To: Kristopher Byrd, Well Construction and Compliance Section Manager
From: Joel Jeffery, Well Construction Program Coordinator
Subject: Review of Well Repair associated with Application G-18542
Date: June 7, 2019

To: Kristopher Byrd, Well Construction and Compliance Section Manager
From: Joel Jeffery, Well Construction Program Coordinator
Subject: Review of Water Right Application G-18542
Date: April 5, 2018

Application # G- 18542

TO: Water Rights Section Date October 30, 2017
 FROM: Groundwater Section Aurora C Bouchier
 Reviewer's Name
 SUBJECT: Application G- 18542 Supersedes review of na
 Date of Review(s)

Figure 3 - Hydrograph: select wells, Jan-May only

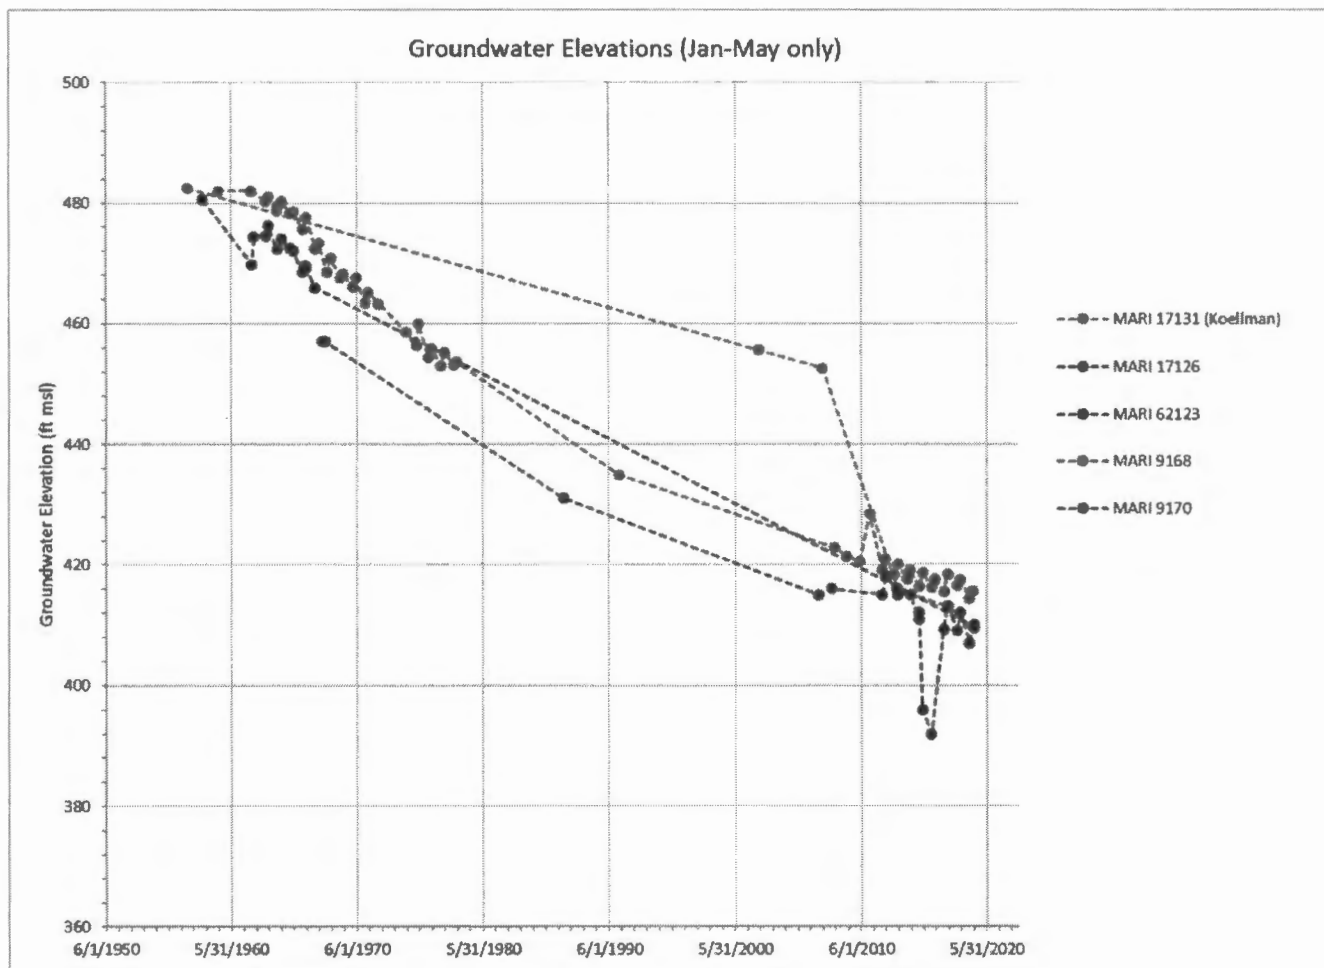
Although there are significant data gaps from the late 1970s until the mid-2000s, a congruent long-term water-level trend for these wells is apparent on Figure 3 and Figure 4, with data from your well falling along the trend in 1956 and again from 2013 through 2019. *This long-term trend, and the similarity of the most-recent 2019 elevations for all five wells, indicates a strong likelihood of consistent hydraulic connectivity between these wells for several decades* (other wells in the Sublimity area with similar water level elevations have also been hydraulically connected for similar periods, for example MARI 9135 and MARI 9167).

From Figure 3 and Figure 4 it can be seen that measurements were made in MARI 9168 and MARI 9170 in 2007 and 2008, the period when you reported a significant decline of water levels in MARI 17131. However, the data for MARI 9168 and MARI 9170 show that water levels in both of these deeper and hydraulically-connected wells were not affected by the installation of MARI 62123 in 2008.

4) We acknowledge that the 2002 and 2007 measurements you reported for MARI 17131 fall outside the general trend depicted on Figure 3 and Figure 4. Those two measurements are not implausible. However, our experience has been that measurement of water levels in MARI 17131 is challenging. During our May 9, 2019 site visit, several shallow false-positive signals were indicated by our equipment before we confidently measured the water level at 73.22 feet below top of casing.

Comparative Lithology / Well Construction Demonstrating Different Water Bearing Zones

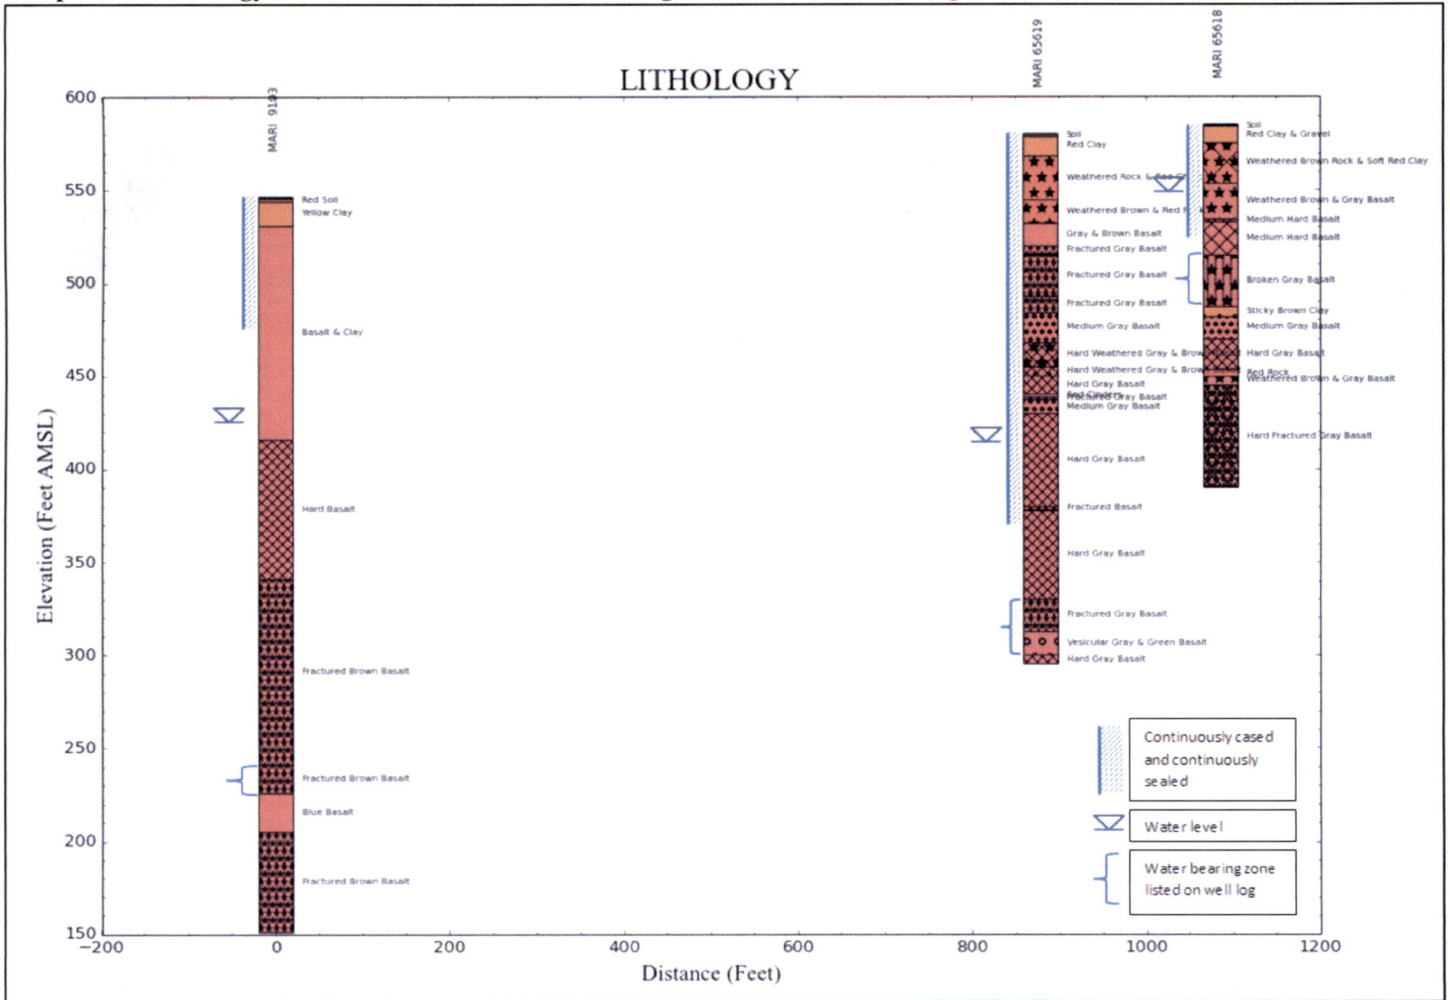
The observance of significantly different water levels in nearby wells of different depths (see Comparative Lithology / Well Construction Demonstrating Different Water Bearing Zones figure below) suggests that there is a poor natural connection between overlying aquifers in the CRBG. This is illustrated by comparing nearby wells MARI 65618 and MARI 65619, both of which were constructed in February 2015, which are located approximately 200 feet from one another, and which have initial water level elevations that differ by approximately 150 feet. These factors indicate that individual water-bearing zones in the basalts are likely to have sufficiently different pressures such that wells open to multiple zones will waste natural reservoir pressure through cross borehole flow. Wells which are open to multiple water-bearing zones with distinct water level heads can commingle multiple aquifers. When the pump is off, water migrates through the well bore from an aquifer of higher pressure to an aquifer of lower pressure. Over time, this can depressurize the aquifers and exacerbate water level declines. MARI 9193 is located approximately 400 feet from the end (A') of the cross section on the Salem East 7.5 geologic map (Tolan et. Al.,2000). Based on its location, MARI 9193 appears to be open to the Sentinel Bluffs, Winter Water, and Ortleigh members of the Grande Ronde Basalt, creating a potential pathway for cross borehole flow (see Comparative Lithology / Well Construction Demonstrating Different Water Bearing Zones figure below).

Water-Level Trends in Nearby Wells

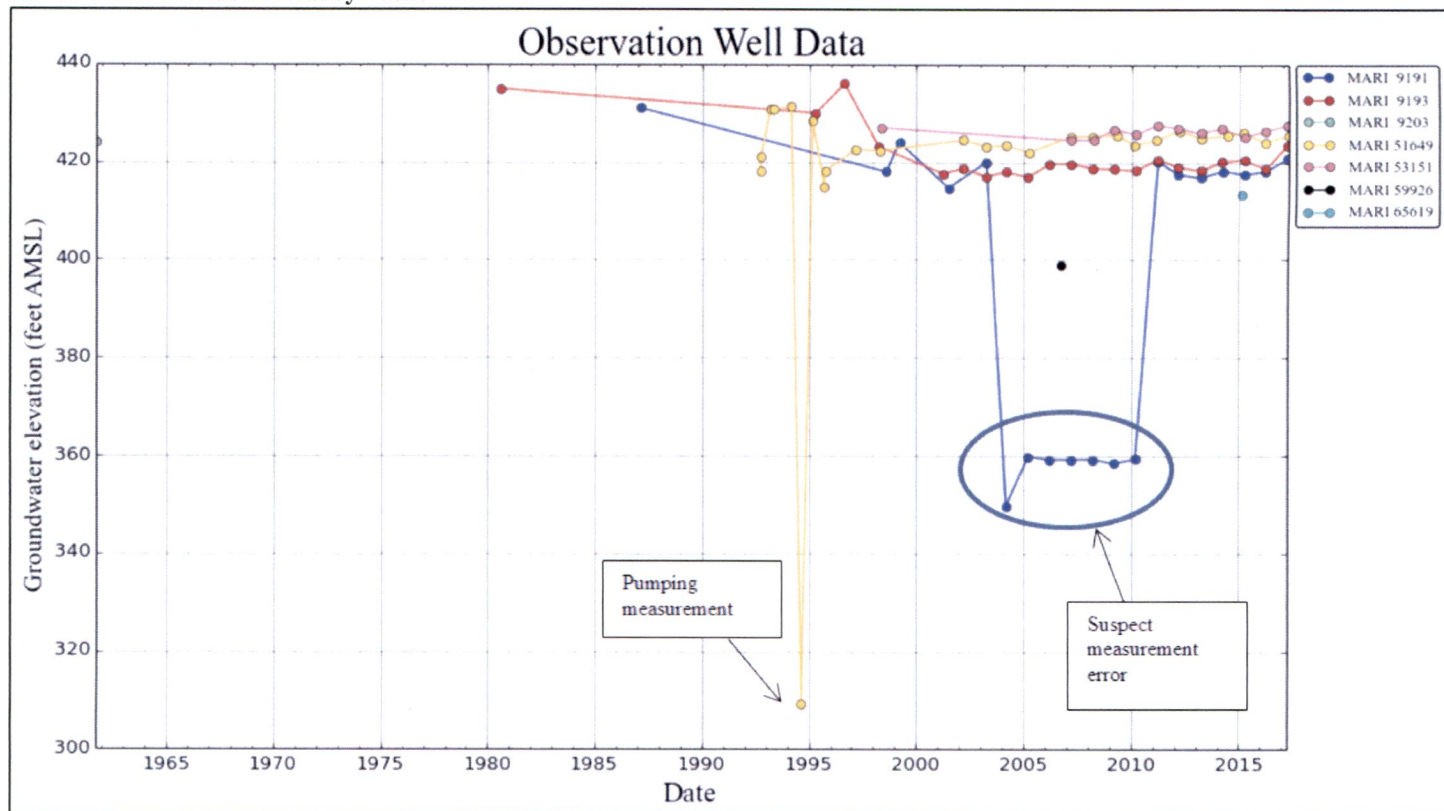
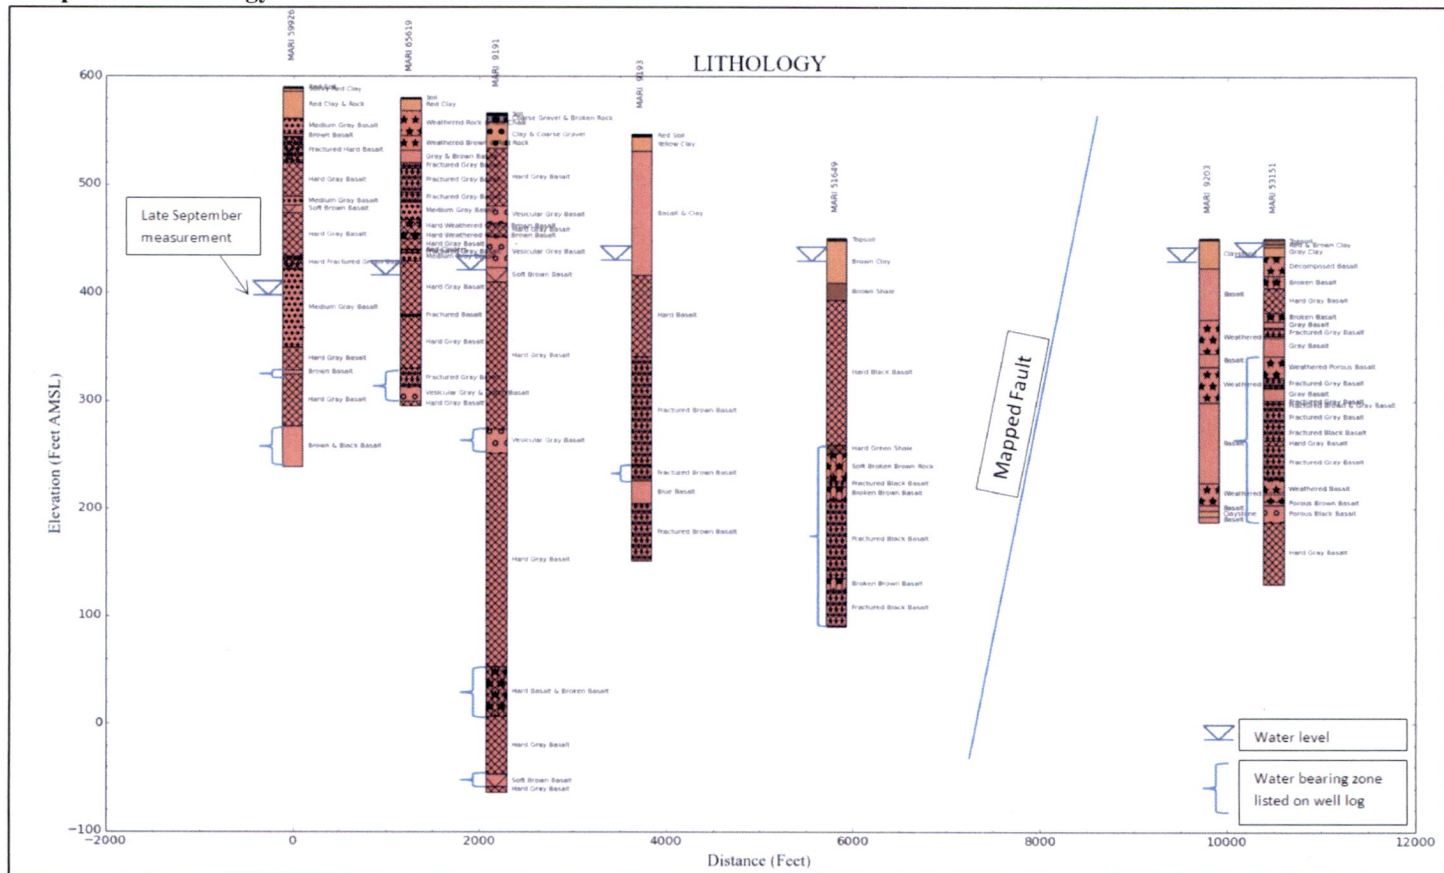
Ground water elevations in the area suggest the water-bearing zone in the applicant's wells may be shared by other groundwater users (both permitted and exempt) in the same fault block and the fault block to the southwest (see hydrograph and second Comparative Lithology graphic below – note that MARI 53151 and MARI 9203 are in the fault block to the southwest). Long term trends indicate relatively stable water levels in the immediate area (within 1 mile), with no significant losses in head within the CRBG aquifers at the current level of use. However, it appears that some nearby permitted water rights have not yet begun production. Specifically, application G-16849 which is authorized for 5.5 cfs by permit G-16373, although all the wells on this permit are located in a different fault block than the applicant's well. It should be noted that the 2002 groundwater review for nearby application G-15880 pointed out declines of up to ~45% of the decline triggers on nearby existing water rights (presumably from wells MARI 9193, MARI 51649, and MARI 9191). The proposed final order recommended denying the permit. A protest was submitted and ultimately the application was withdrawn. Subsequent water level measurements since 2002 show stable water levels (see hydrograph below).

Screenshot Showing A' End of Cross Section (Tolan et. Al., 2000) and MARI 9193 Construction/Lithology

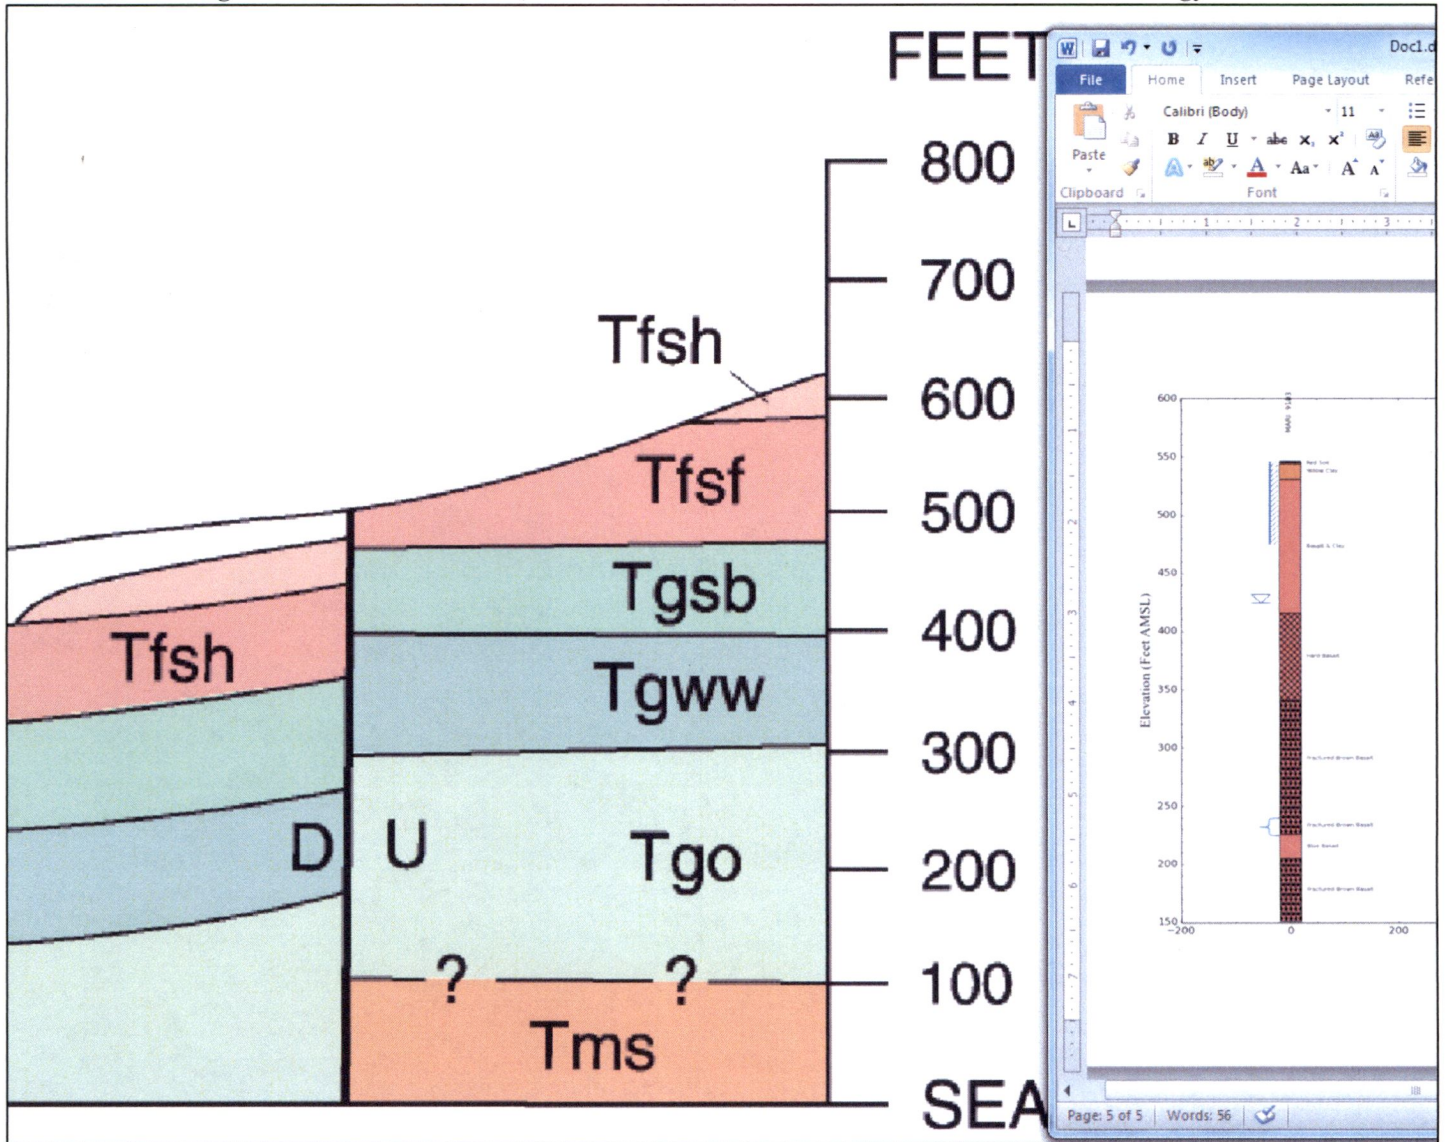
The well is cased and sealed to a depth of 99 feet in a layer described as 'basalt with clay seams' (from 15 to 130 feet). Water was first encountered at a depth of 305 feet in a layer described as 'basalt w/ brown fractures' (from 203-320 feet) and rose to a static water level of 111 feet (194 feet above the zone at which it was first encountered).
